LOCKHEED
MISSILES & SPACE COMPANY
A GROUP DIVISION OF LOCKHEED AIRCRAFT CORPORATION
SUNNYVALE, CALIFORNIA

ECO/ECP/TI NO.	DATED	DWG TITLE		DWG NO.	REV LTR
		STRUCTURE ASSEMBLY, AFT BULKHEAD		4174146	C02
WO-EWA/RWA-JOB NO. FLM-VK201-0161-01X		STRESS	DATE	DWG. TO BE CHANGED ☒ YES ☐ NO	SHEET 1 OF 2 / DCN ☐ LEO ☒
PREPARED BY A. KOELLING 62-93	ORGN. NO. / DATE 89.07.31	MATERIAL	DATE	MULTIPLE USAGE APPROVALS	MODEL / CHANGE EFFECTIVITY
CHECK W. Bakulous	DATE 89 8 3	MFG PLANNING	DATE		
PROJECT ENGR H. GREENFIELD	DATE 89.07.31	DESIGN CHANGE CONTROL	DATE		
PRODUCTION ENGR	DATE	CUSTOMER	DATE		RECOMMENDED DISPOSITION OF PARTS/MATLS ☐ USE ☐ REWORK ☐ SCRAP

REASON
CUSTOMER DIRECTION (REF: CCB #3101)

3
8B

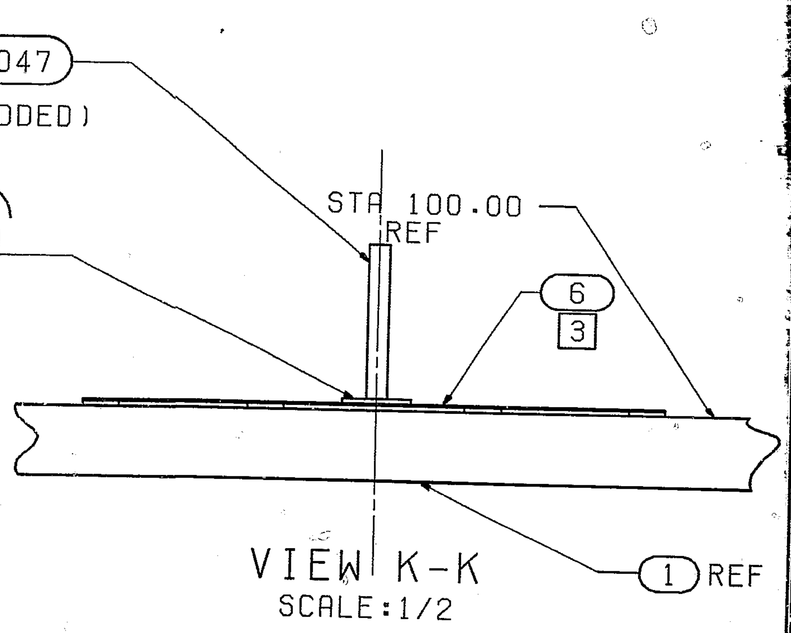
DESCRIPTION OF CHANGE
ZONE

(ADDED)

.143
.149 DIA THRU ITEM 47

.109
.111 DIA THRU ITEM 6.

LOCATE FROM PILOT
HOLES IN ITEM 47.
